PLANNING BOARD MEETING

Tuesday, February 20, 2024 at 6:00 PM

1. Site Plan & Design Review - Short Street

9 SHORT STREET REAR YARD MODIFICATION RANDOLPH, MASSACHUSETTS

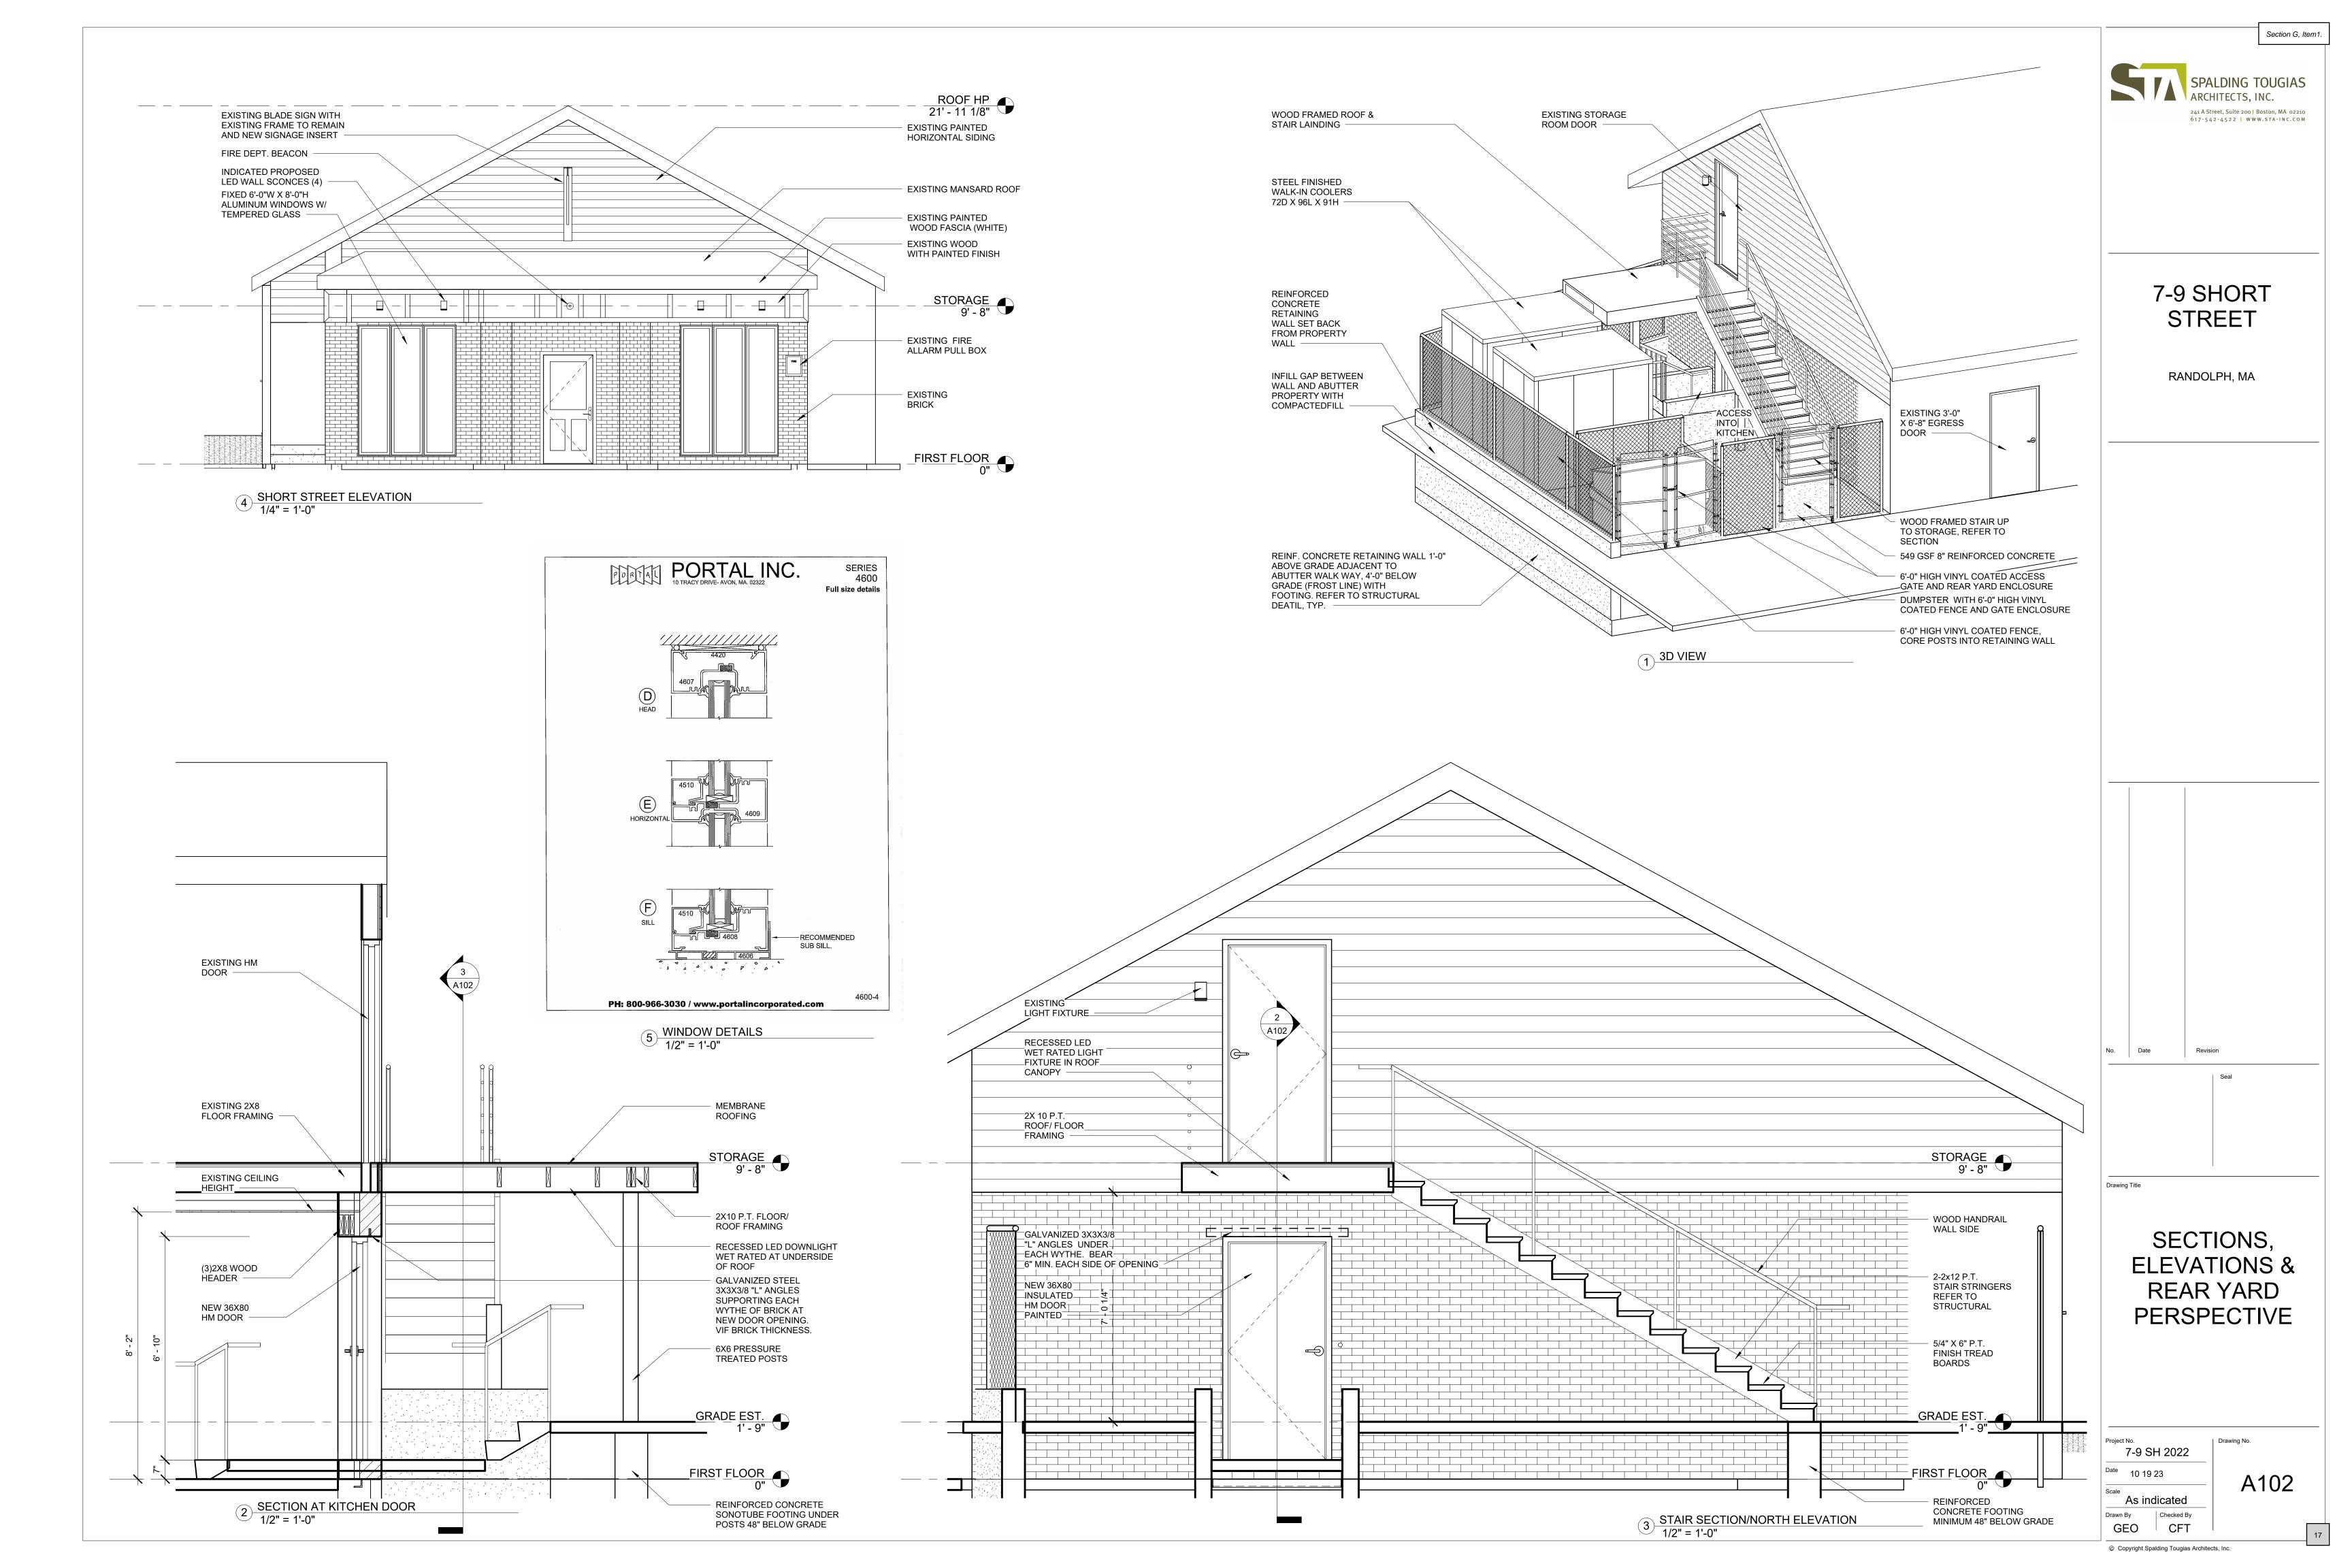
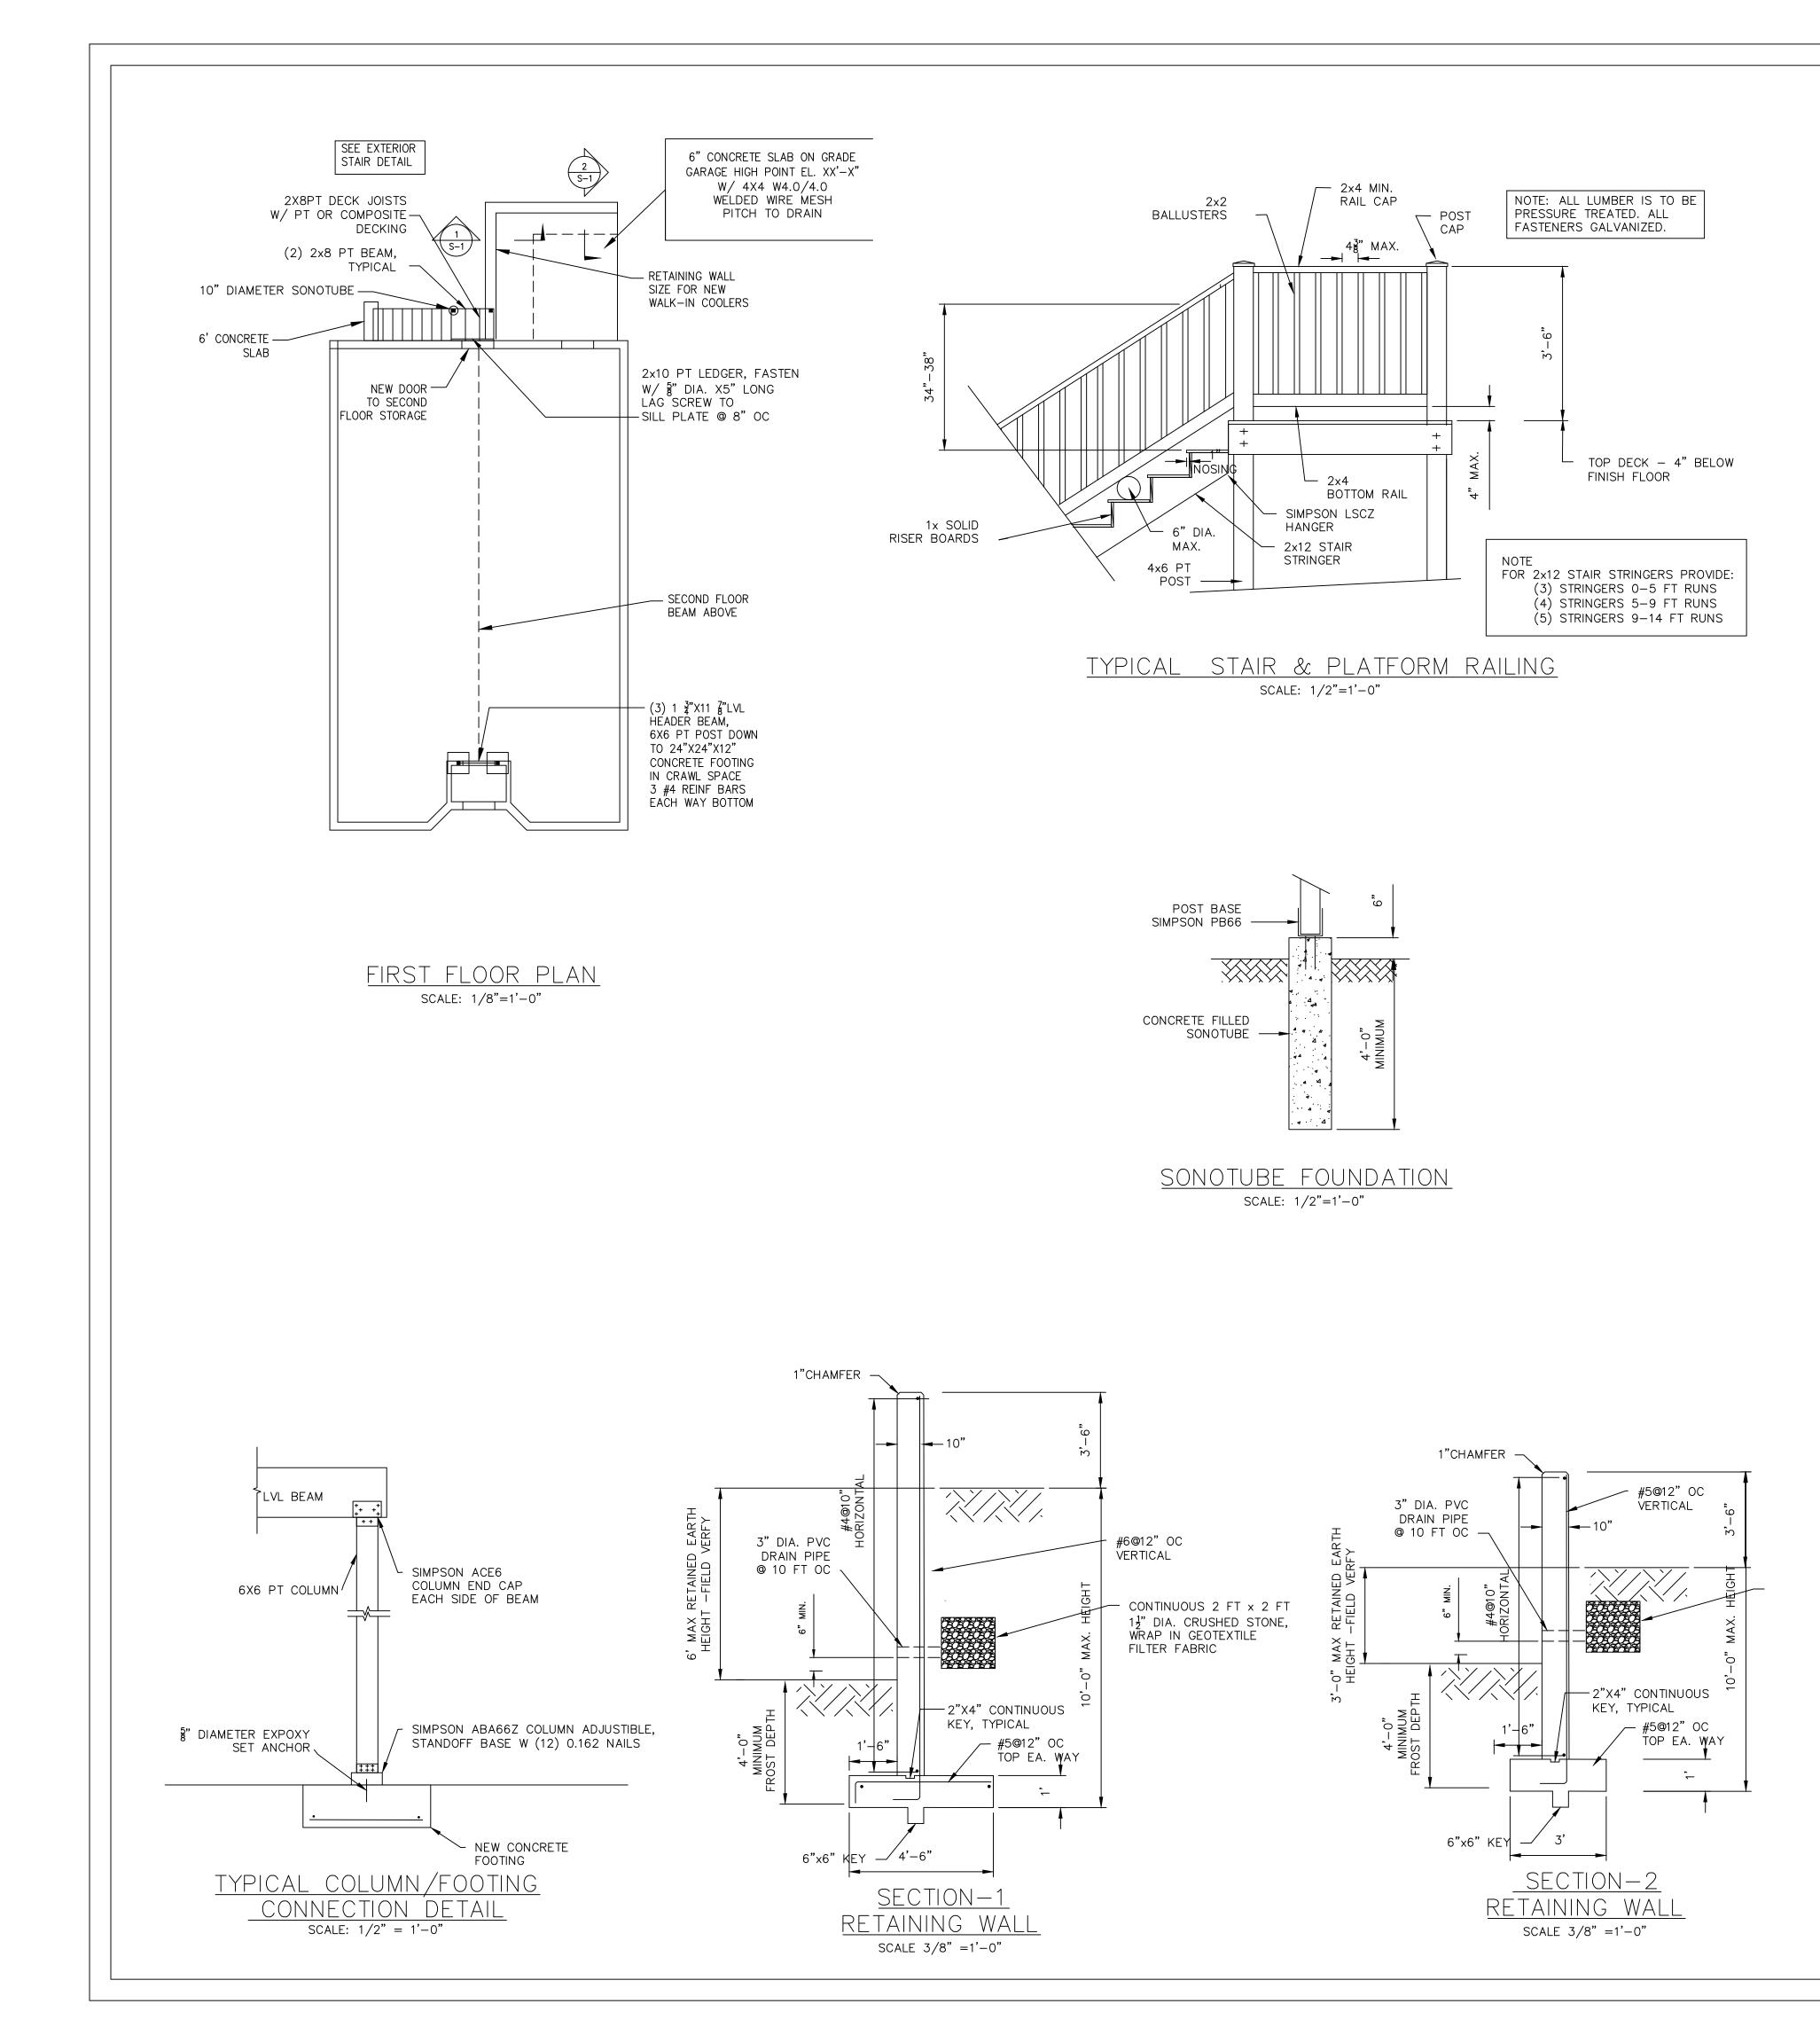
- a. Pictorial renderings (page 4) depict a new door on the eastern side of the structure but there is no corresponding reference on the civil plans A-101). Either the civil plan or the pictorial renderings submitted should be correct to accurately indicate the intent.
- b. The plan set (A-101) indicated concrete sloping to a "private way". There is no private way associated with the parcel. Plan notes should be corrected.
- c. The plan set (A-101) indicates the fencing is vinyl coated fence but the narrative with spec sheets calls out a fence panel. Either the civil plan or the pictorial renderings submitted should be correct to accurately indicate the intent.
- d. The plan set (A-101) calls out a drain at the landing but no plan set includes the placement of a dry well.
- e. The plans do not call out roof drains and how the run-off will be managed.
